### **SITE DESIGN REVIEW (SDR) FOR A SECOND-UNIT**

160 California Street

July 21, 2021/aha

**Project Address:** 160 California St.  
**Permit Number:** PREAPP-2021-00259  
**Description:** Second Unit  
**AF&R Contact:** Ralph Sartain  
541-552-2229  
[ralph.sartain@ashland.or.us](mailto:ralph.sartain@ashland.or.us)

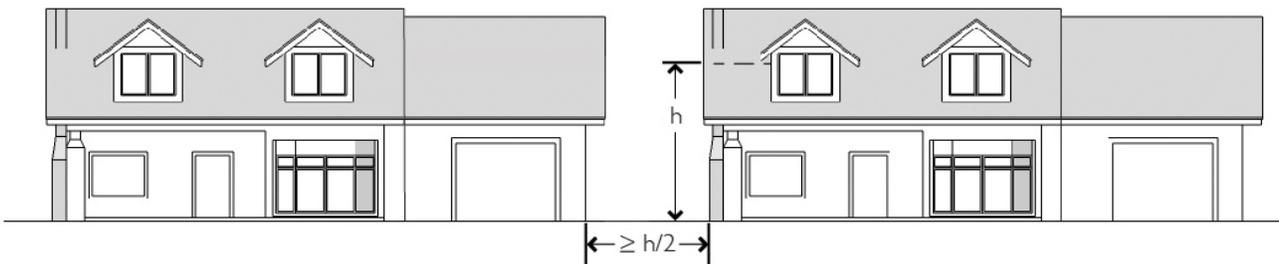
- Unified Standards for Residential Zones are found on-line at: <https://ashland.municipal.codes/LandUse/18.2.5>
- **Setbacks:** California Street is consider to be the property’s front yard. Standard setbacks are 20 feet for the front yard, six feet for the side yard adjacent to 172 California Street, ten feet for the side yard adjacent to Quincy Street, and ten feet per story for the rear year opposite California Street.
- **Separation Between Buildings:** The required separation between buildings on an R-3 lot is one-half the height of the tallest building, where building height is measured at the two closest exterior walls as illustrated below. The maximum required separation is 12 feet.

Note: Maximum required building separation is 12 feet.
